BROIL ELEMENTS
 #1,2,7,8 CONTROLLED
 3,4,5,6 - UNCONTROLLED
 9,10,11,12

BROIL ELEMENTS

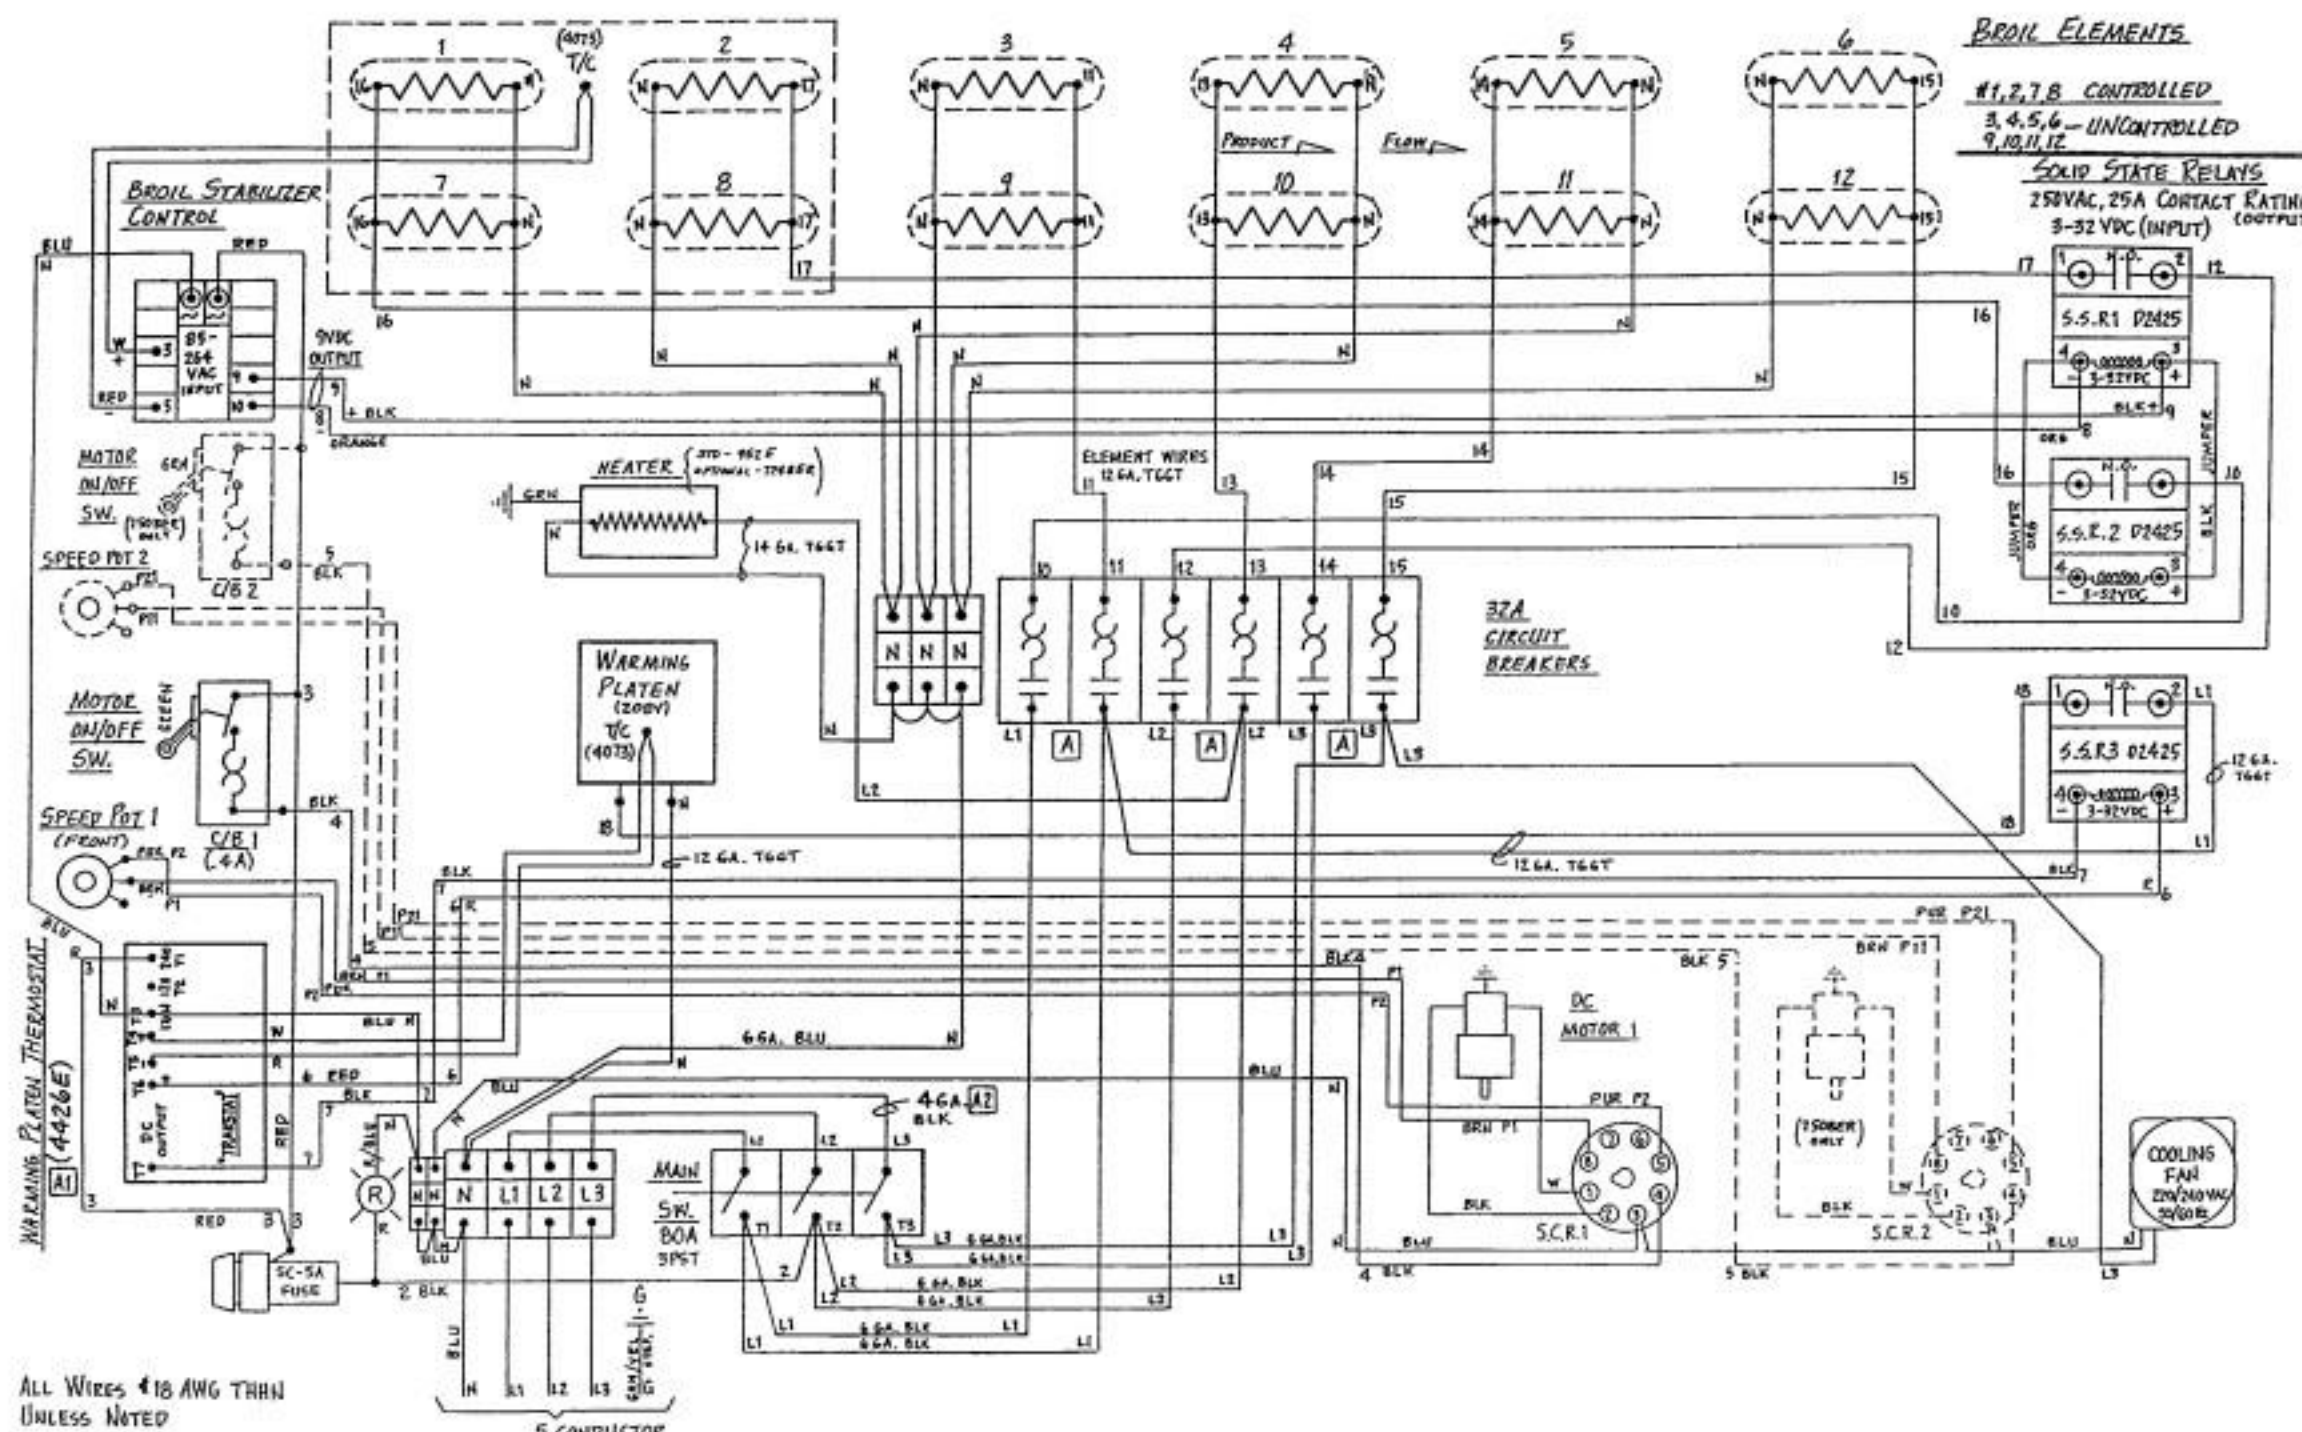
A NEW PLATEN THERMOSTAT, DELETE C/B JUMPER, INCREASE WIRE SIZE. WAS #1 N 4011-P240C (2) 6GA. 11-7-95 02

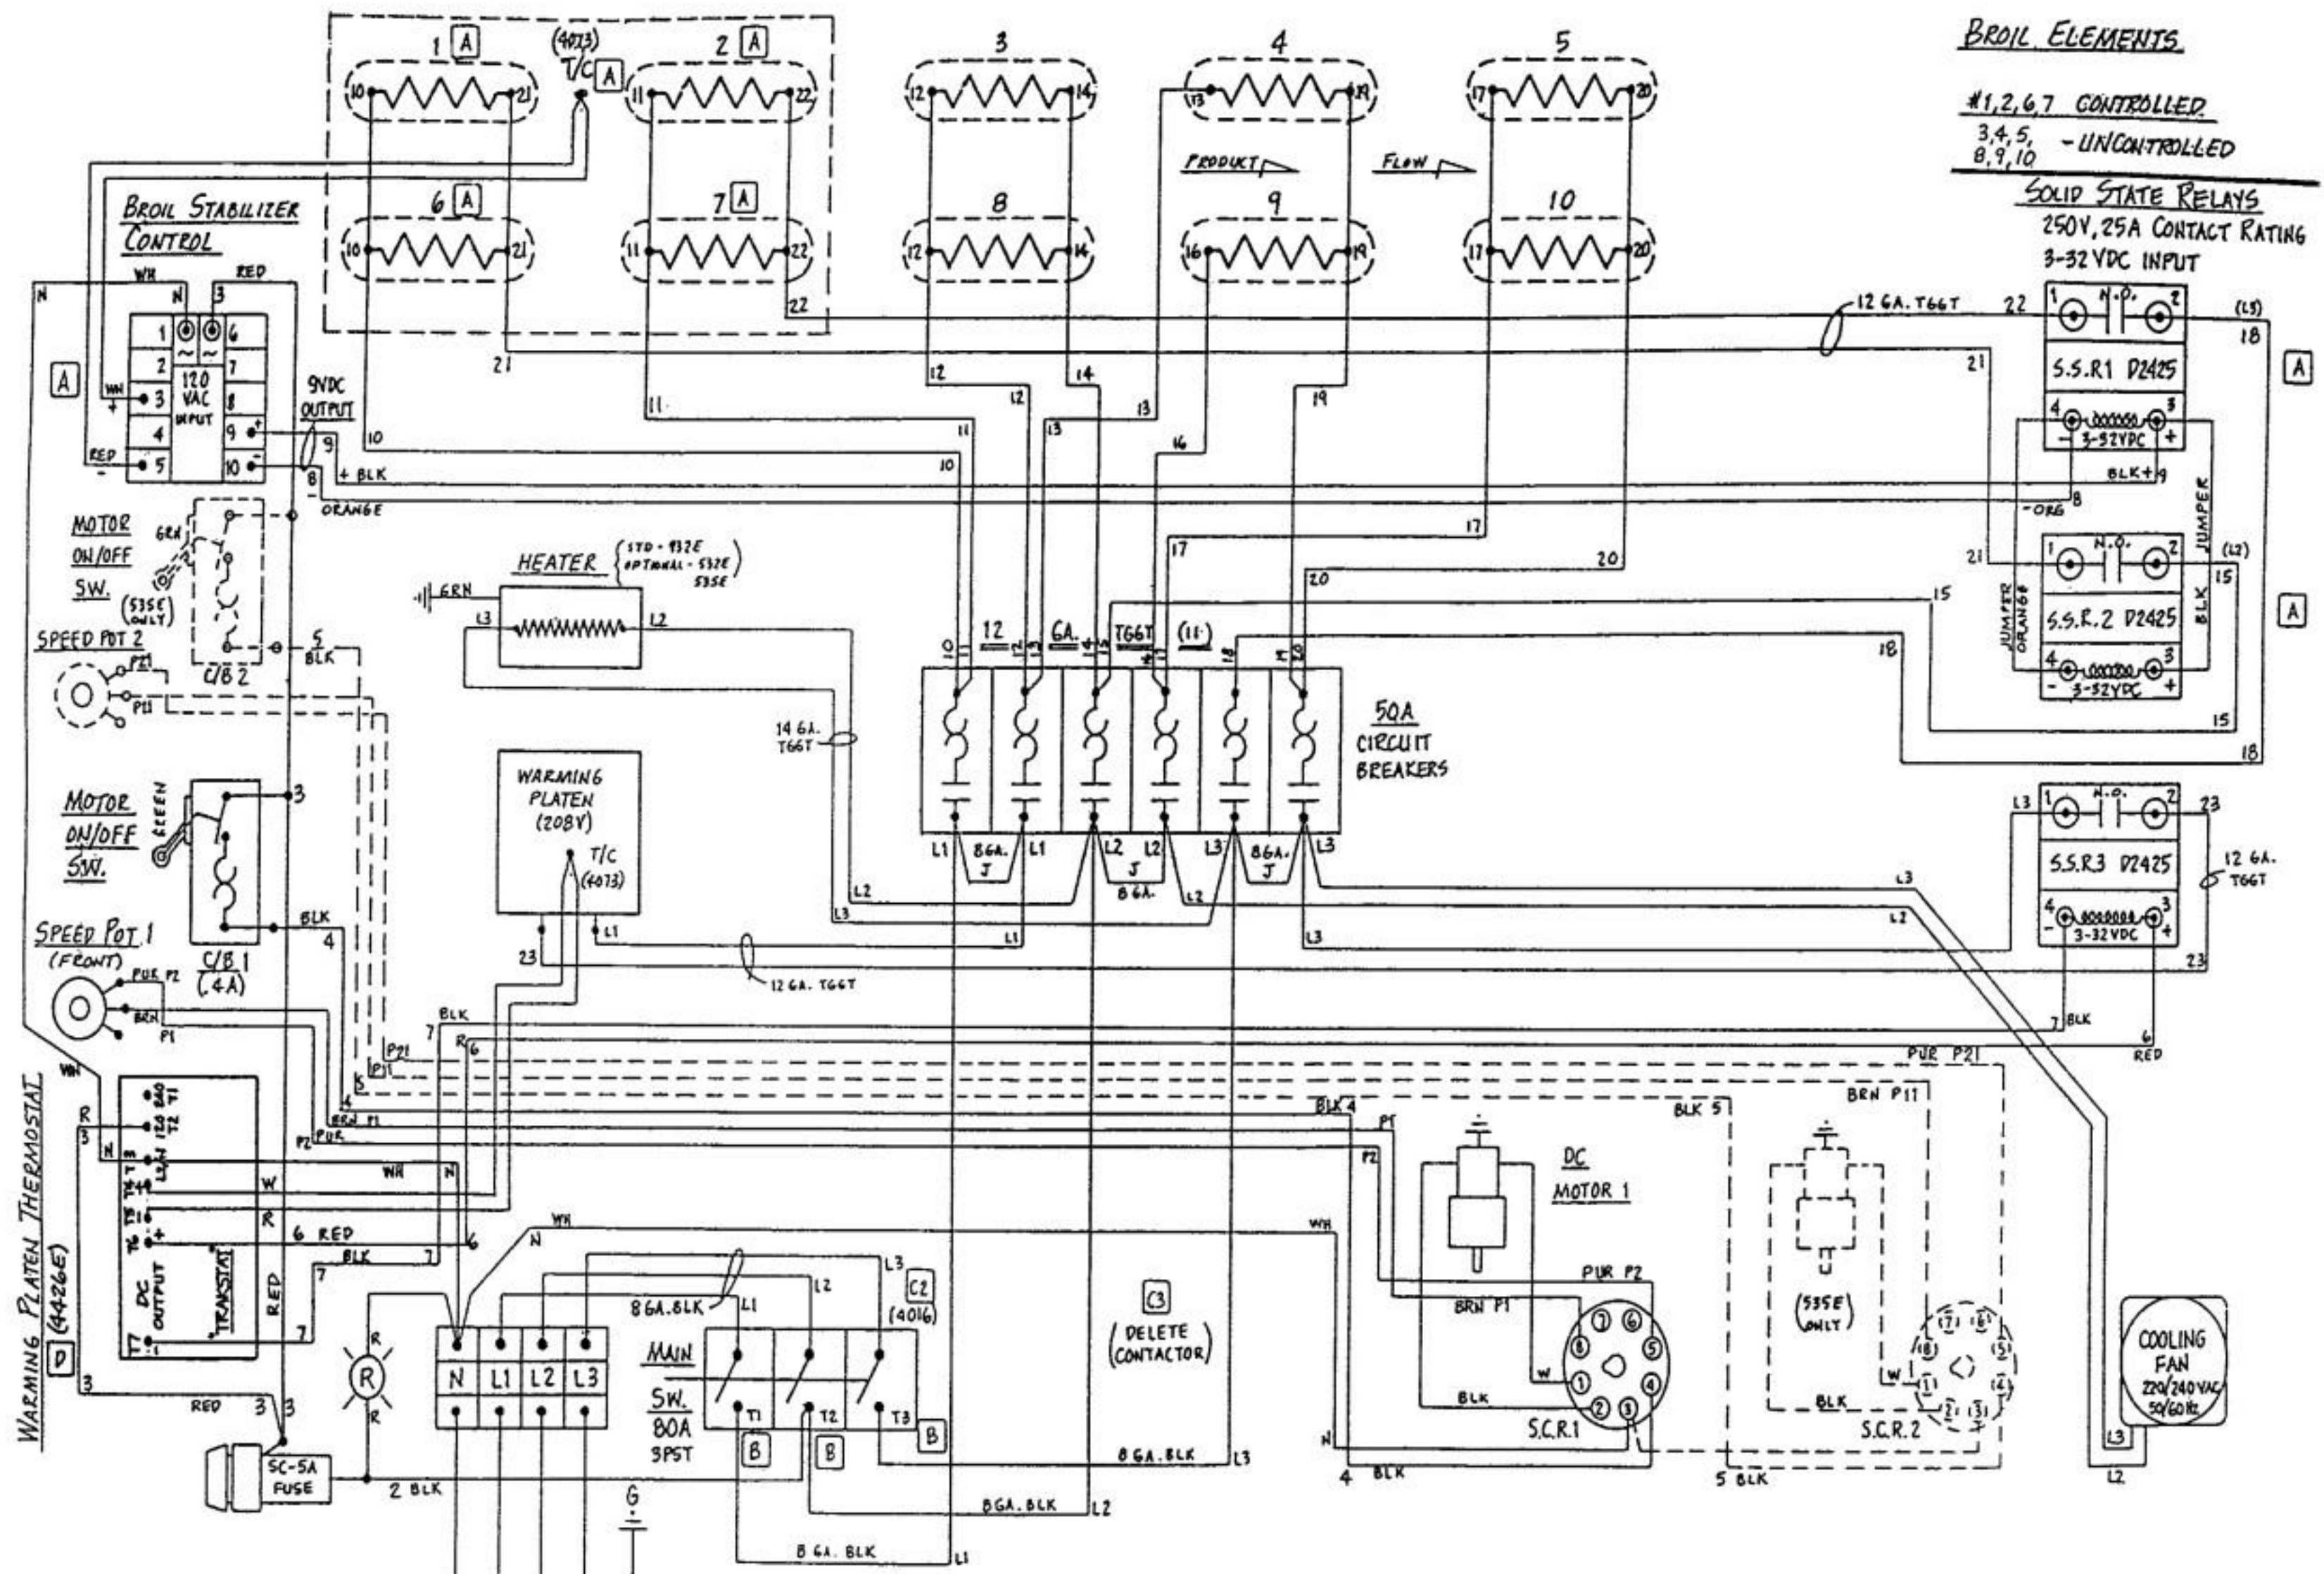
A NEW PLATEN THERMOSTAT, DELETE C/B JUMPERS, INCREASE WIRE SIZE. WAGO (1) PH 4071-PMAC (2) 6 GA. 11-7-95 DZ

17

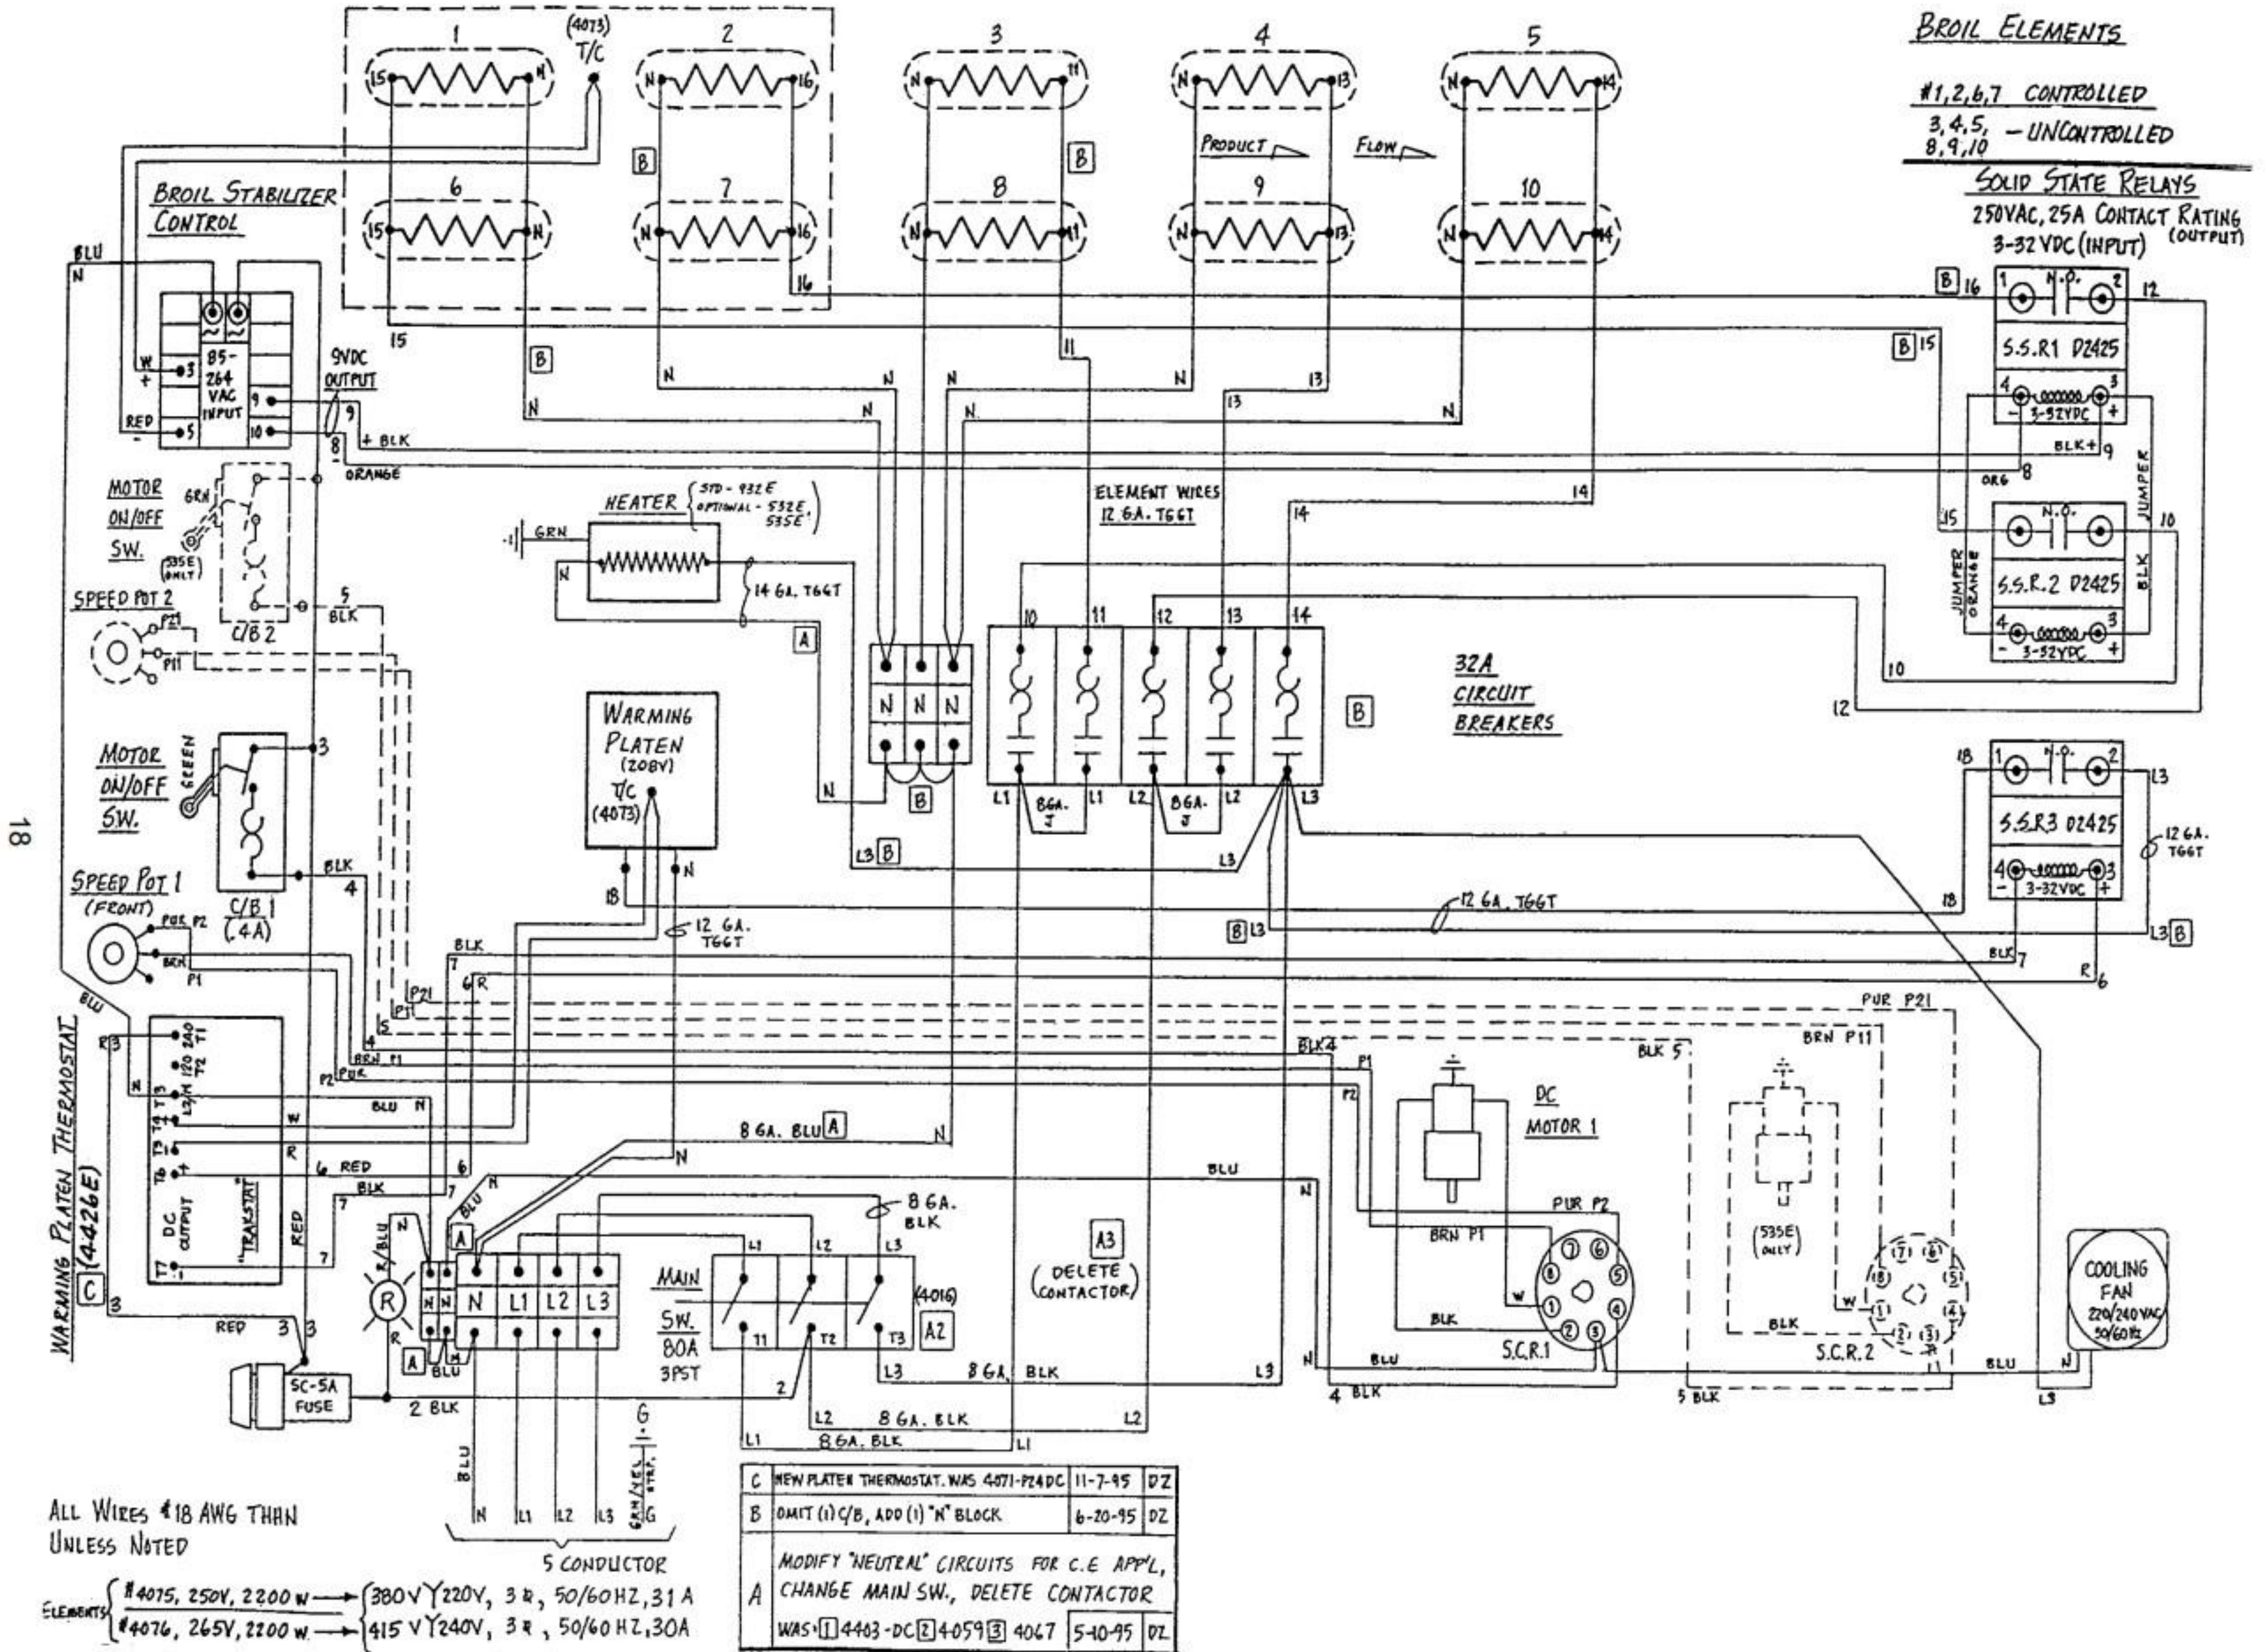
D	NEW PLATEN THERMOSTAT. WAS P/N 4071-P240C	11-7-95	DZ
C	CHANGE PLATEN ATC, MAIN SW., DELETE CONTACTOR, ADD 2ND SCR. WAS: 1 44039C 2 4059 3 4067	5-10-95	DZ
B	RE-LABEL CONTACTOR FOR U.I.	9-16-94	DZ
A	RE-DMN. WAS: (4) ELEMENTS, (1) ATC, (1) SSR, (1) T/C	7-14-93	DZ

C	NEW PLATEN THERMOSTAT WAS 4071-P24DC	11-7-95	DZ
B	OMIT (1) C/B, ADD (1) "N" BLOCK	6-20-95	DZ
MODIFY "NEUTRAL" CIRCUITS FOR C.E APP'L, CHANGE MAIN SW., DELETE CONTACTOR			
	WAS: [1] 4403-DC [2] 4059 [3] 4067	5-10-95	DZ
